October 30, 1998
RC-98-0202

Subject: VIRGIL C. SUMMER NUCLEAR STATION
DOCKET NO. 50/395
OPERATING LICENSE NO. NPF-12
REQUEST FOR ADDITIONAL INFORMATION
REGARDING RESPONSE FOR GENERIC LETTER 96-06
(TAC No. M96872)
*"Assurance of Equipment Operability and Containment
Integrity During Design-Basis Accident Conditions"*

**RESPONSES TO USNRC
REQUEST FOR ADDITIONAL INFORMATION
PERTAINING TO V. C. SUMMER NUCLEAR STATION
RESPONSE TO GENERIC LETTER 96-05**

FIGURE 1

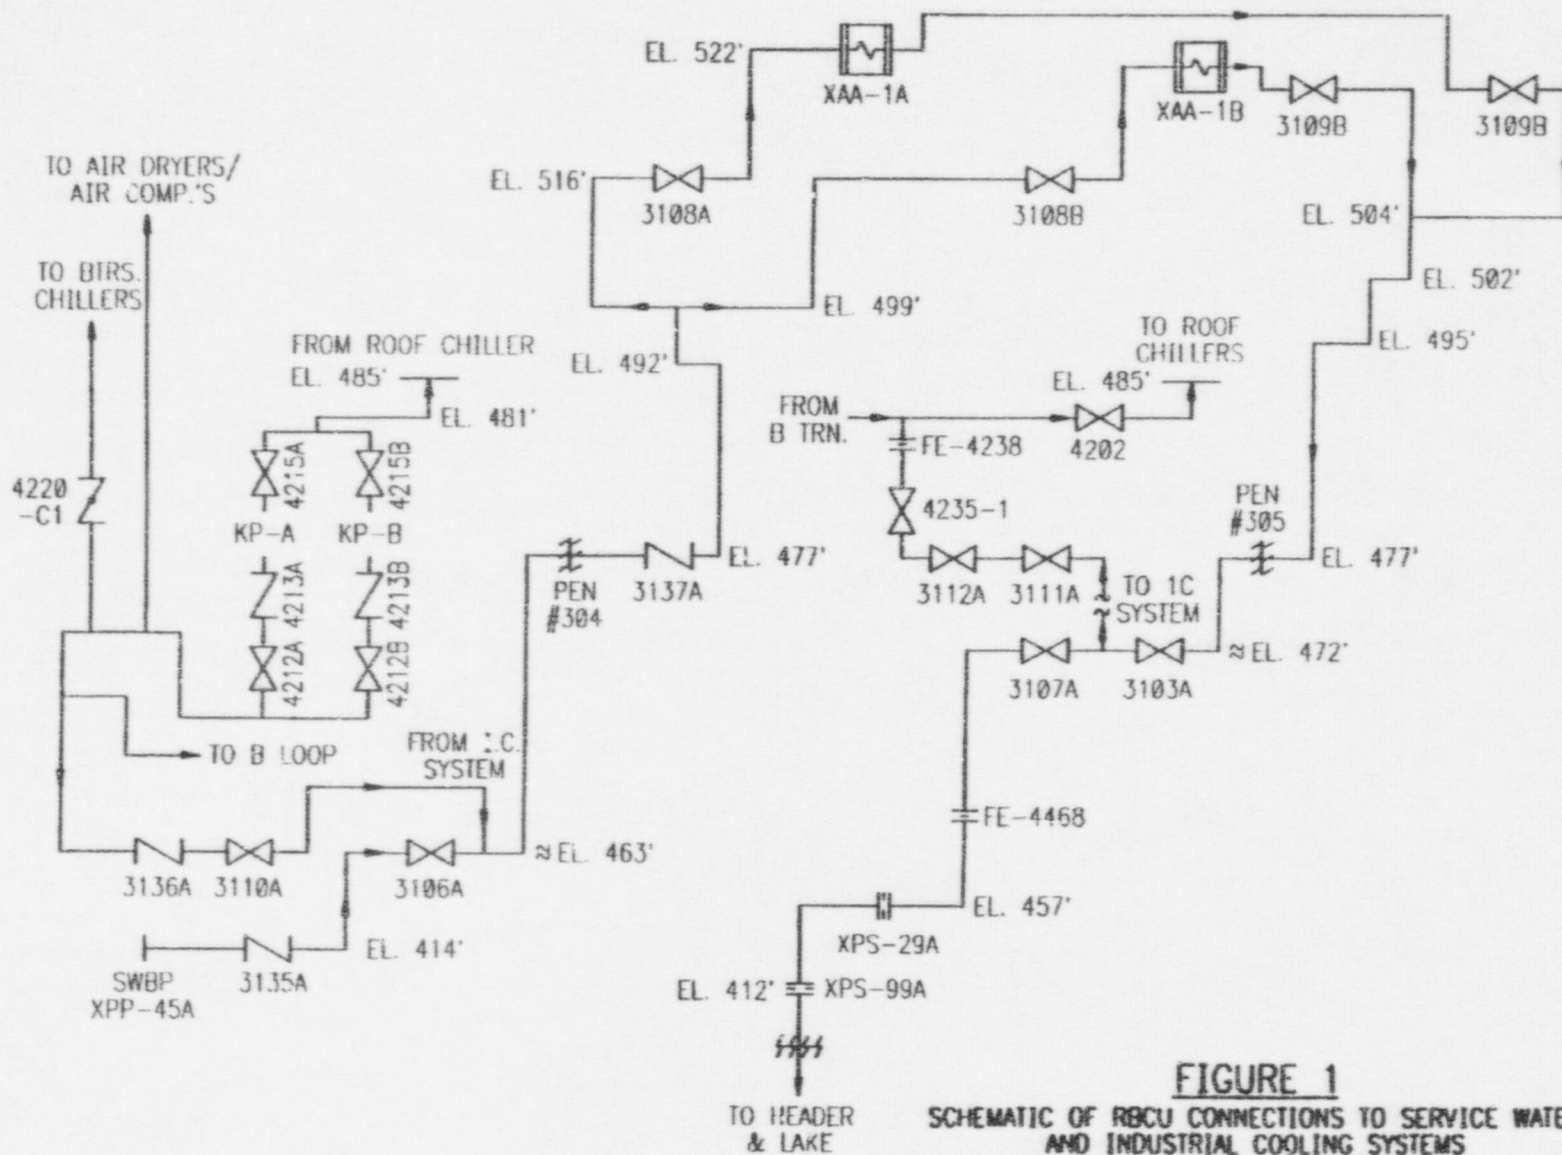
- 6. Provide a simplified system diagram showing major components, active components, relative elevations, lengths of piping runs, and the location of any orifices and flow restrictions.**

6. See attached Figure 1 "Schematic of RBCU Connections to Service Water and Industrial Cooling Systems". Representative piping lengths are not readily available in a simplified format. This information is in isometric drawings and our original research documentation for Generic Letter 96-06, which is available for on-site review, if desired.
- 7. Describe in detail any plant modifications or procedure changes that have been made or are planned to be made to resolve the water hammer and two phase flow issues, including completion schedules.**
